Ref: SSD-
83431958

**RE: SUBMISSION TO SSD-83431958 FOR CONSTRUCTION OF 9 STOREY
RESIDENTIAL FLAT BUILDING WITH IN-FILL AFFORDABLE HOUSING**

Address: 16 & 18 Middle Harbour Road, Lindfield

Ku-ring-gai Council's objection to SSD-83431958, for construction of 9 storey residential flat building with in-fill affordable housing at 16 & 18 Middle Harbour Road, Lindfield

Figure 2: The lower and upper ground floor plans highlighting in green where the COS is located, many of which is not useable as shown on the Landscape Composite Masterplan

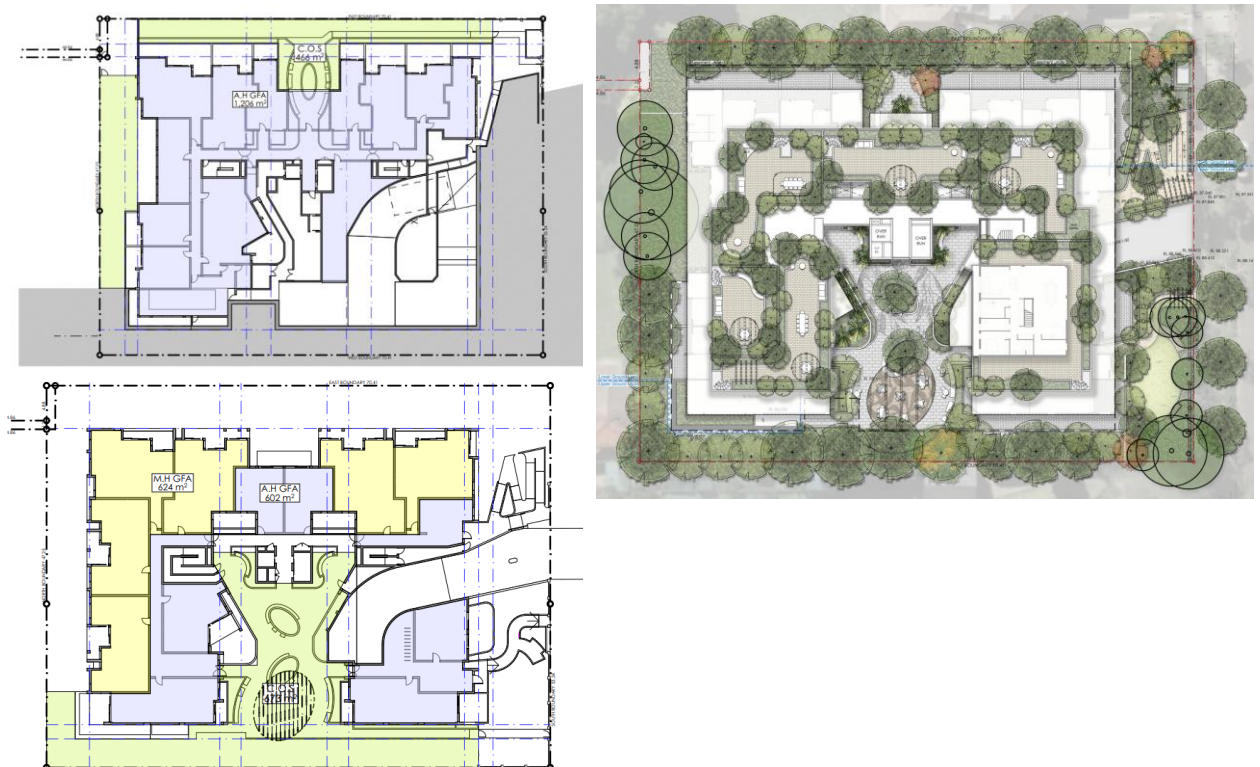
Under the proposed development, some of the communal open space is fragmented and consists of narrow strips of landscaping along site boundaries, which the submitted landscape plans indicate will be planted with shrubs and ground cover. These areas cannot reasonably be considered communal open space under the ADG definition, as they are not usable or capable of supporting recreation or social interaction. Furthermore, the majority of the communal open space located on the lower ground level to the east is covered by the building above at the upper ground level, significantly diminishing solar access, amenity, and usability.

Council considers that the design of the communal open space must be revised to ensure compliance with intent of the ADG. Consolidated, uncovered, and genuinely usable areas should be provided that deliver opportunities for active and passive recreation, social interaction, and landscaping amenity. Boundary planting and residual covered spaces should not be counted towards the communal open space provision, as this undermines both the quality of the development and the amenity of its future residents.

Figure 3: Deep soil plan, showing 4 metres to the northern and western boundaries and 3 metres to the eastern boundary

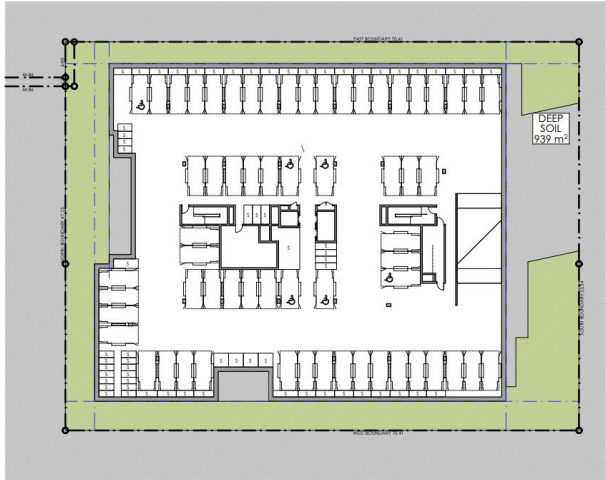
Under the proposed development, building setbacks of only 4 metres to the northern and western boundaries and 3 metres to the eastern boundary are proposed. These widths fall short of the 6-metre minimum dimension required for sites of this size. Narrow side setbacks cannot be considered deep soil zones under the ADG definition, as they do not provide sufficient soil volume to support healthy tree growth and do not deliver the intended environmental or amenity benefits. As such, the quantum claimed substantially overstates the actual provision of deep soil.

Council therefore forms the view that the proposed development does not comply with the ADG's deep soil requirements. The design should be revised to incorporate genuine, consolidated deep soil zones with minimum 6-metre dimensions, capable of supporting large canopy trees and meeting Objective 3E-1. Without such changes, the development will fail to provide the environmental and residential amenity outcomes required by the ADG.

Figure 5: An example where a bedroom relies on a 9-storey void for daylight

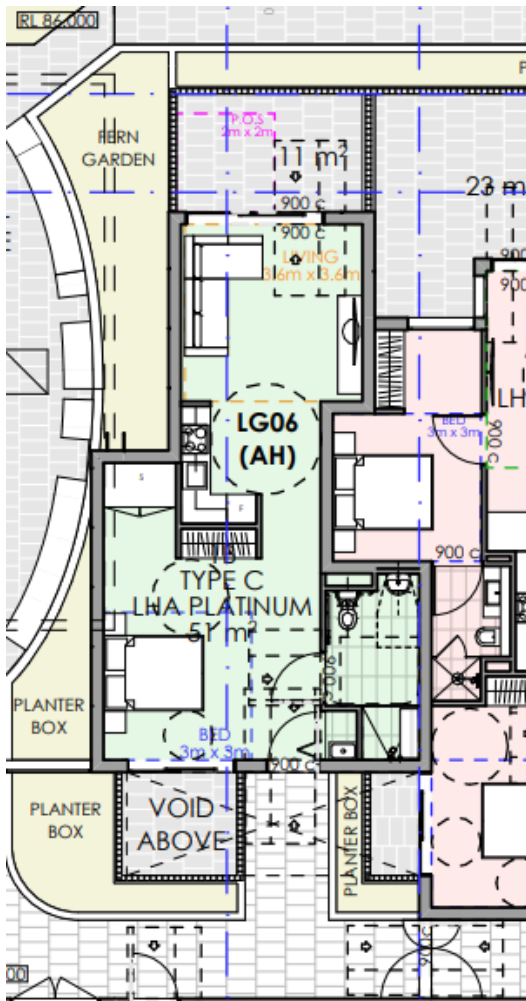
Under the proposed development, 19 apartments are affected where one or more bedrooms rely solely on a window to a deep light/ventilation void. Given the void extends nine storeys in height, daylight penetration is significantly compromised, and these rooms are left dependent on a secondary light source as their primary daylight provision. This approach does not comply with the ADG and results in an unacceptably low level of amenity for affected residents.

Additionally, it is noted that these bedroom windows relying on lightwells as the primary natural light source, are also located in very close proximity to common pathways which will result in acoustic impacts, exacerbating the poor level of amenity to the subject bedrooms.

Council considers it essential that the proposal be redesigned so that all habitable rooms, including bedrooms, receive adequate direct natural light in accordance with the ADG.

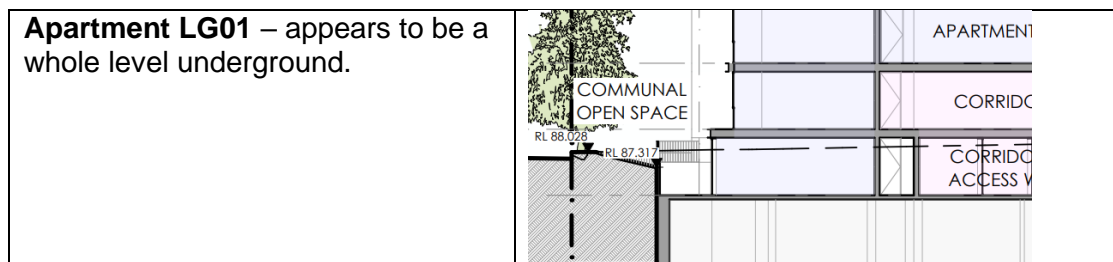
In this proposal, several apartments appear to breach this requirement as demonstrated in the submitted sections. LG09 and LG01 appear to be a full level below ground, while LG02 and 111 appear to be set more than one metre below existing ground level. Based on the available sections, these are the only examples visible; however, it is likely that other units are similarly affected. These layouts raise significant concerns regarding natural light, ventilation, outlook, and amenity for residents, and are inconsistent with the intent of the KDCP control.

<p>Apartment LG02 – appears to be more than 1m underground.</p>	
<p>Apartment LG09 – appears to be a whole level underground.</p>	
<p>Apartment 111 – appears to be more than 1m underground.</p>

Council considers that the design of these units must be revised to comply with the requirement for ground floor apartments to be no more than 0.9 metres below existing ground level. Without such changes, these dwellings will present as sub-grade apartments with poor amenity, contrary to both the KDCP and the objectives of the ADG.

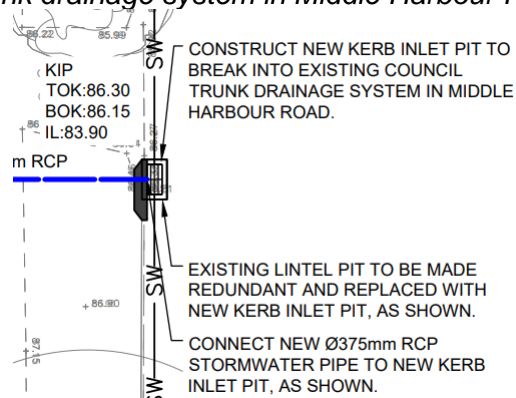
The submitted BDAR has misclassified the vegetation community on site as Blue Gum High Forest (PCT 3136). Based on the BDAR's own floristic data, which records Tree 9 *Syncarpia glomulifera* (Turpentine) as the dominant canopy species, the correct classification is Sydney Turpentine-Ironbark Forest (STIF; PCT 3262). STIF is listed as a Critically Endangered Ecological Community under the BC Act 2016. This error requires correction, and all offset calculations and impact assessments must be revised to reflect the correct PCT.

concern is Tree 9 (*Syncarpia glomulifera*), which is a canopy tree contributing to the STIF community. The report states that Tree 9 is subject to total encroachment by the proposed building footprint and cannot be retained. The removal of Tree 9 has not been justified in accordance with the mitigation hierarchy under Section 3 of the Stage 2 BAM Operational Manual, which requires that biodiversity impacts be avoided before reliance is placed on offsets. At present, the proposal fails to demonstrate genuine avoidance of this impact.

The BDAR must be revised to identify the vegetation as Sydney Turpentine-Ironbark Forest (PCT 3262) and offsets recalculated. In addition, the applicant must demonstrate avoidance of Tree 9 through redesign or, if removal is unavoidable, provide detailed justification consistent with BAM requirements
